12153

St Clare Business Park – Hampton Hill

1.1 This engineering note has been prepared in response to comments received from the LLFA regarding the proposed drainage strategy at the St Clare Business Park in Hampton Hill.

SCALE: 1:250@A1 DATE: Sept' 19 DRAWN: BD CHK'D: AJP
DRG NO. 12153-CIV-200 REV. D

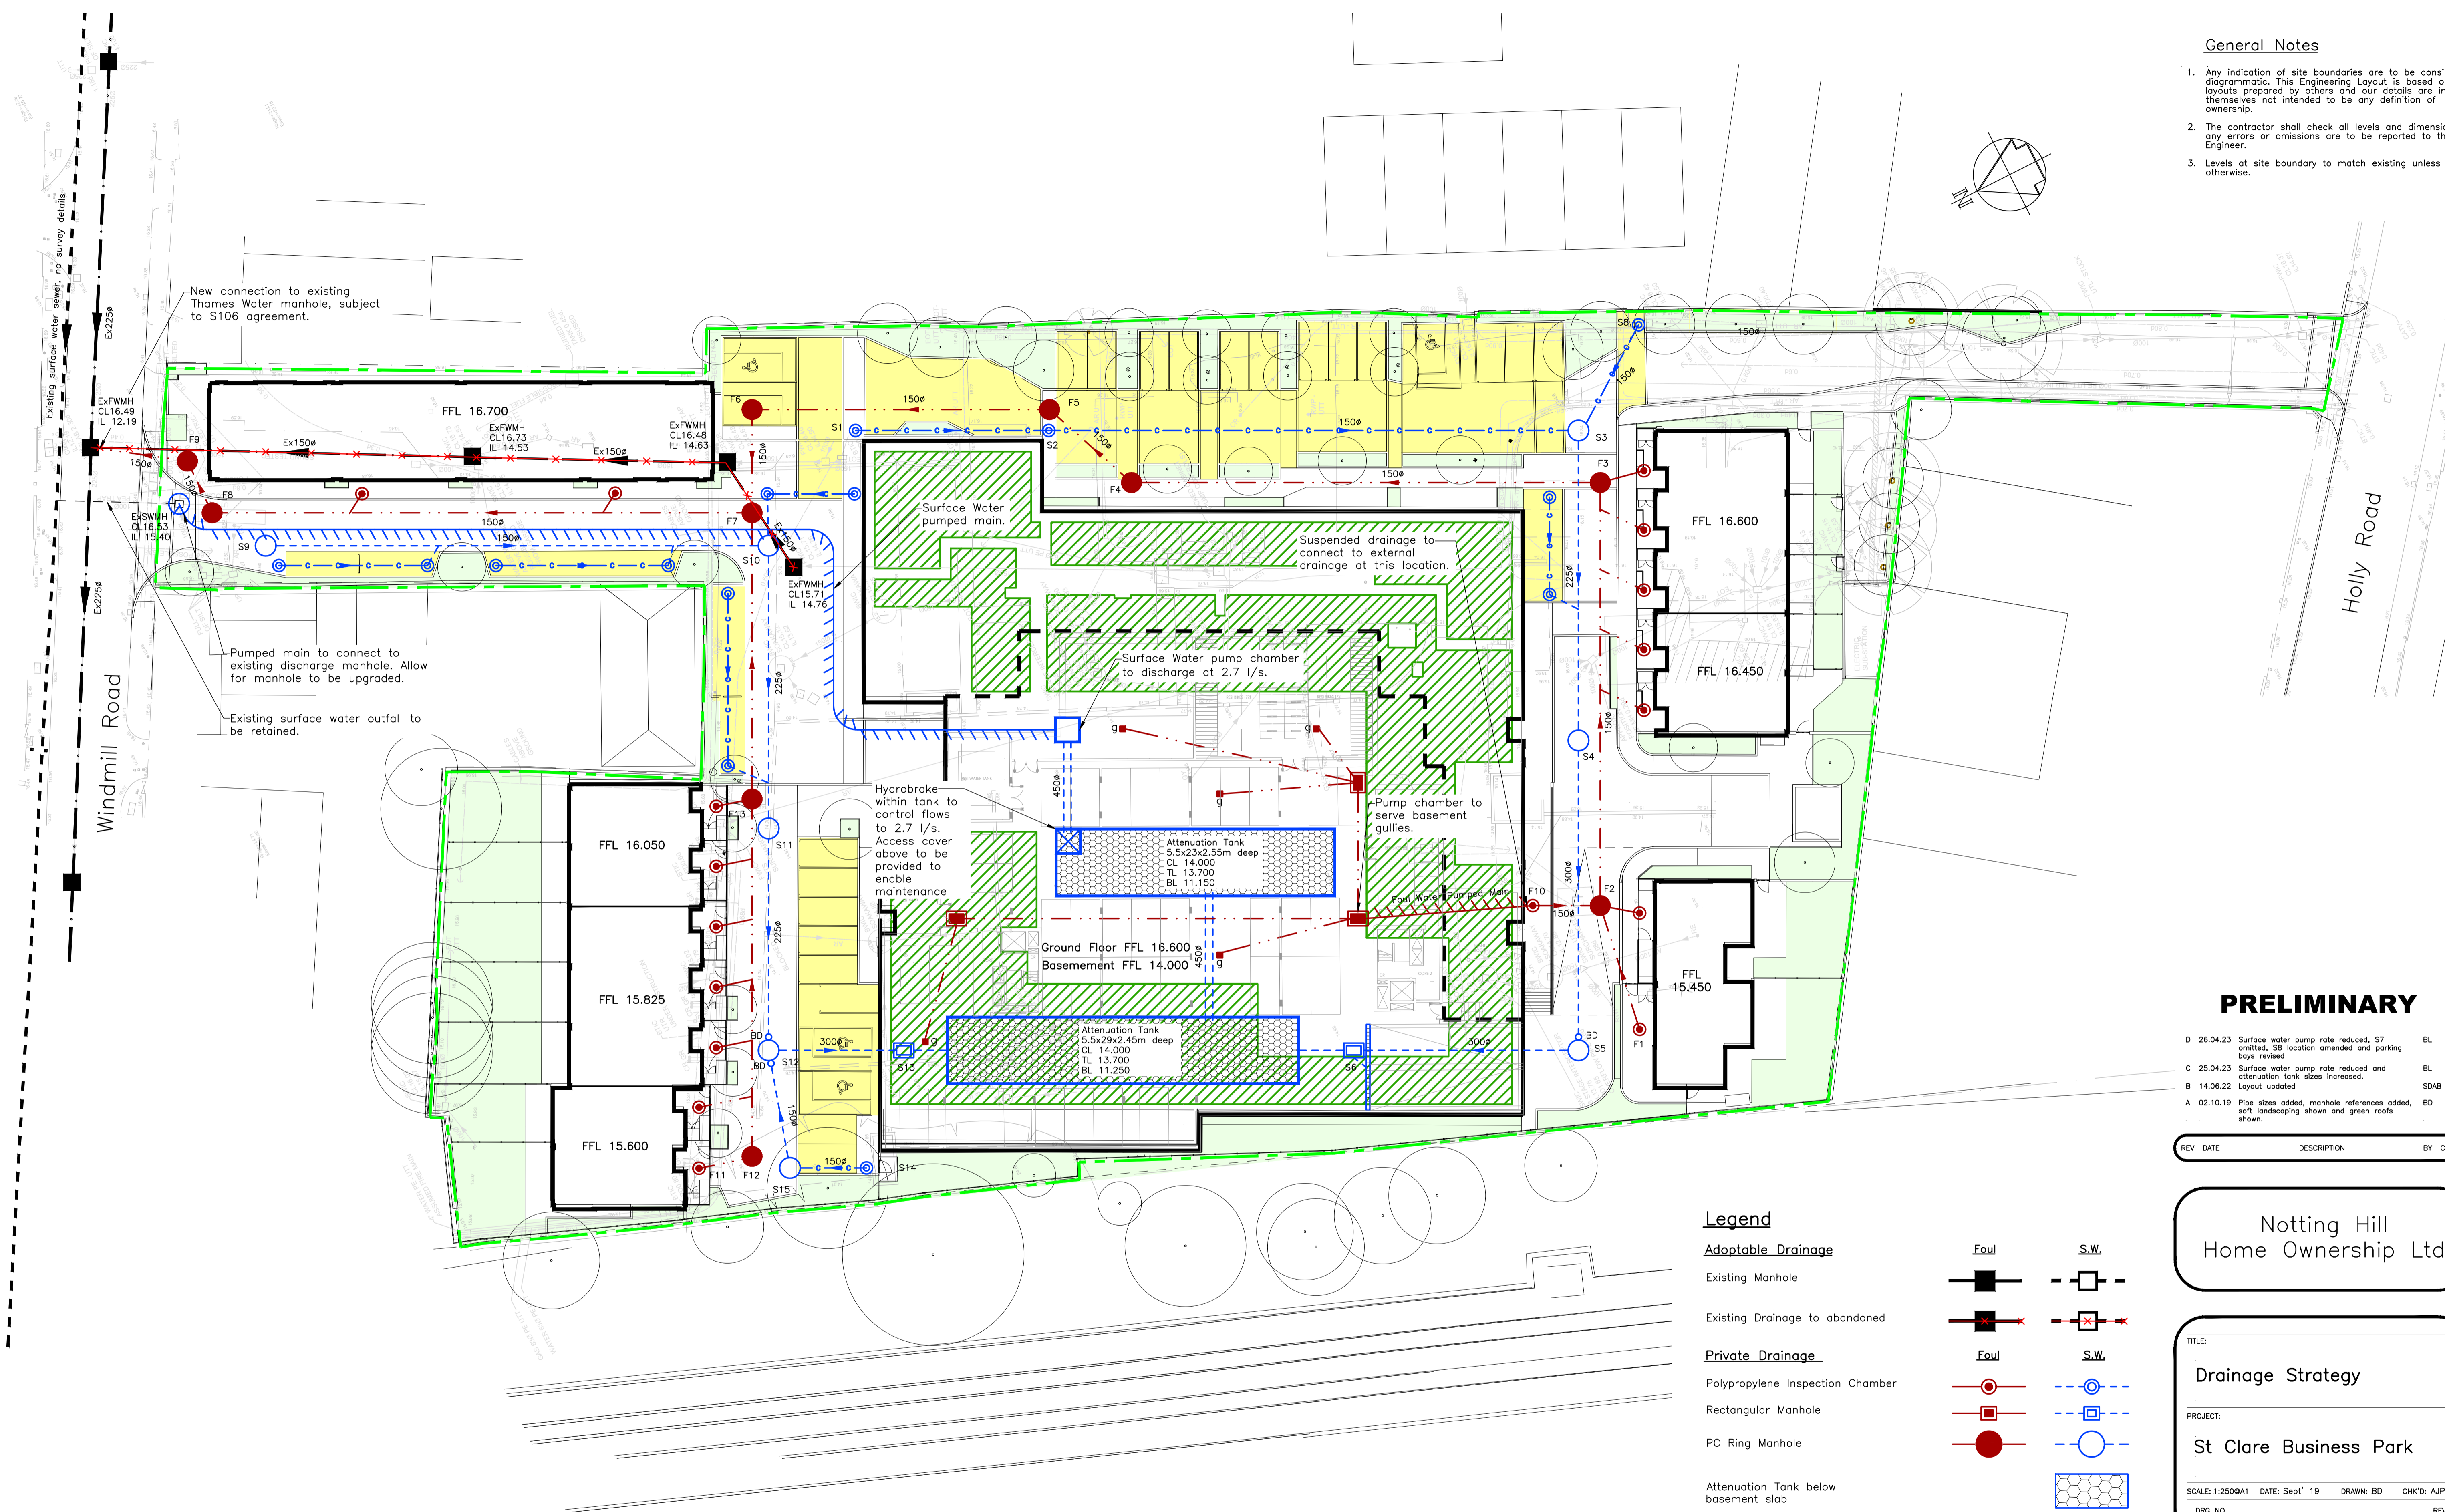
2.1 In response to the LLFA requesting surface water runoff rates to be restricted to a maximum of 2.0 l/s, we have been in discussions with pump suppliers who have advised that they do not recommend pumping surface water at a rate lower than 2.7 l/s for a situation such as this due to concerns over the potential long running times. The minimum discharge rate they have recommended is 2.7 l/s and to protect the pump set, a hydro-brake has been added upstream of the pump chamber. We have re-run the MicroDrainage calculations based upon a discharge rate of 2.7 l/s, which has resulted in a required increase in surface water attenuation of 74m³. To accommodate this, both of the below ground attenuation tanks will be increased in width by 0.5m. To summarise:

- Attenuation required at 5 l/s = 634m³
- Attenuation required at 2.7 l/s = 707m³
- Attenuation provided by increasing tank width by 0.5m = 713m³

2.2 Refer to Appendix A for an updated Drainage Strategy drawing and MicroDrainage calculations.

| D 26.04.23 | Surface water pump rate reduced, S7 omitted, S8 location amended and parking bays revised. | BL AJP |
| C 25.04.23 | Surface water pump rate reduced and attenuation tank sizes increased. | BL AJP |
